Arlington County Department of
Environmental Services
DES

**Construction Standard Details
2020**

**Update #1
February 2023**

The following Standard Details are modified or added to the 2020 DES Construction Standard Details:

1	2/28/2023
ISSUED	9/14/2020
DRAWING NO. W-9.5

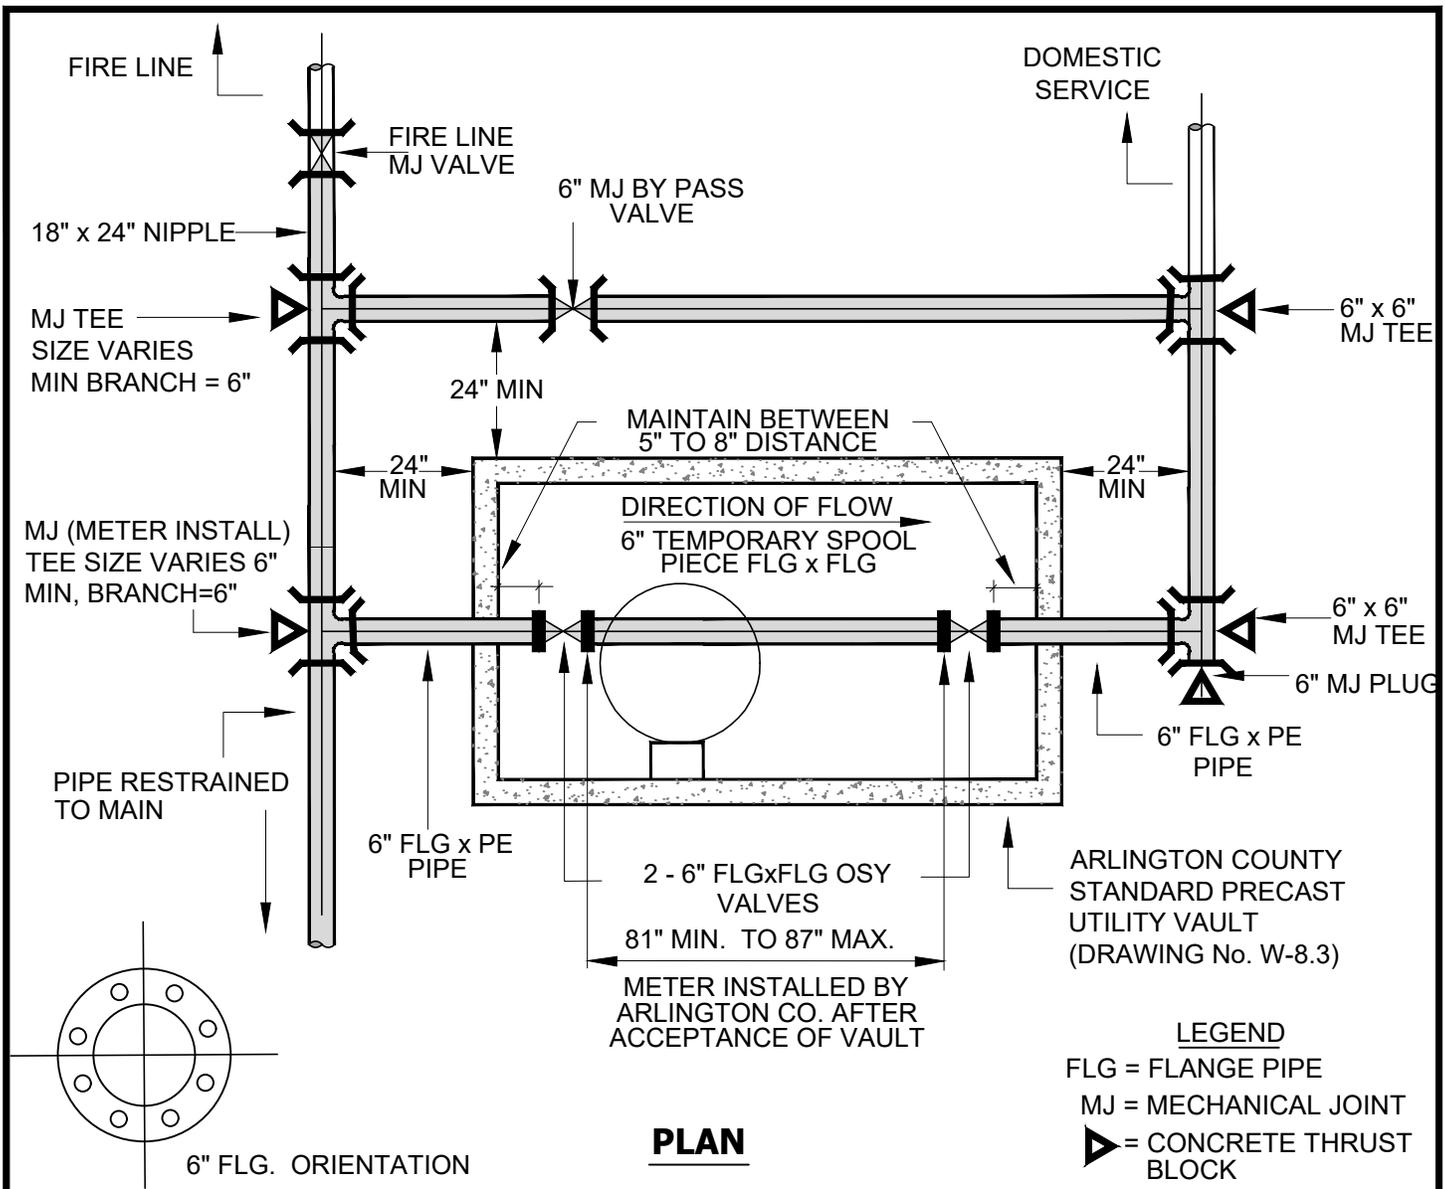
Detail W-9.5 Water Meter Installation 6 Inch Service by Developer [Modification]

- Updated ‘2 - 6” FLG x O.S.&Y. FLG Valves’ to ‘2- 6” FLGxFLG OSY Valves’
- Reference to MEGALUGS removed from Note 4
- Concrete Thrust Blocks are bolder

1	2/28/2023
ISSUED	9/14/2020
DRAWING NO. W-9.6

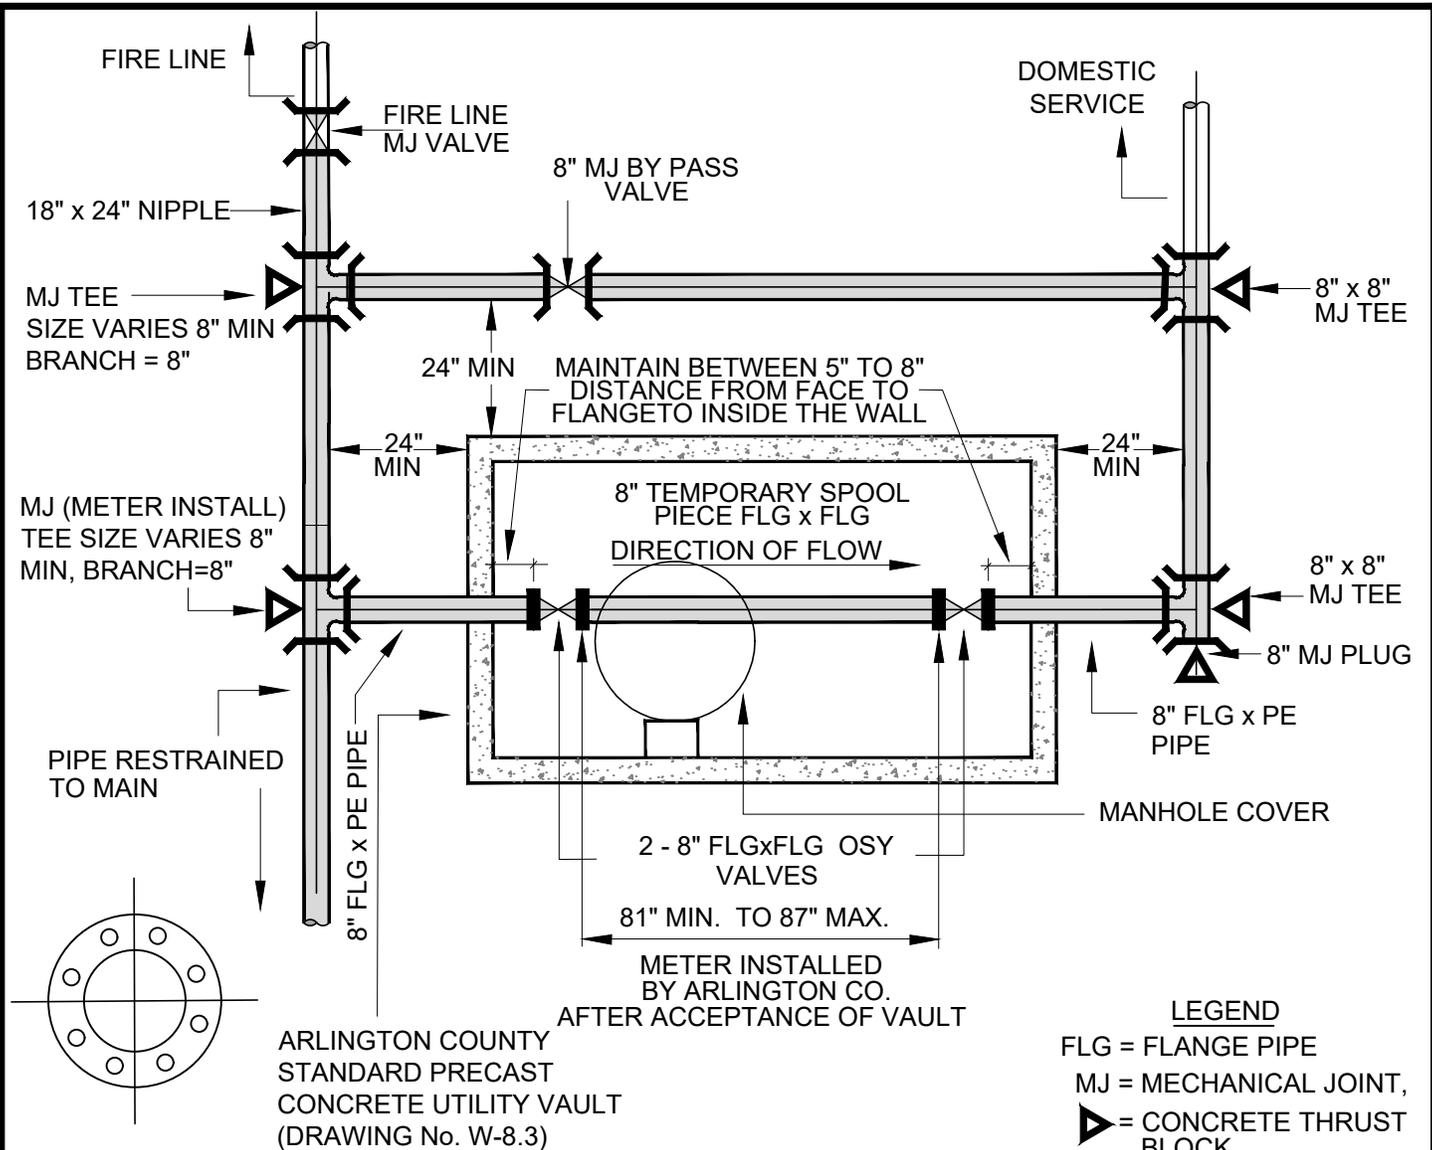
Detail W-9.6 Water Meter Installation 8 Inch Service by Developer [Modification]

- Updated ‘2 - 8” FLG x O.S.&Y. FLG Valves’ to ‘2 - 8” FLGxFLG OSY Valves’
- Reference to MEGALUGS removed from Note 4
- Concrete Thrust Blocks are bolder
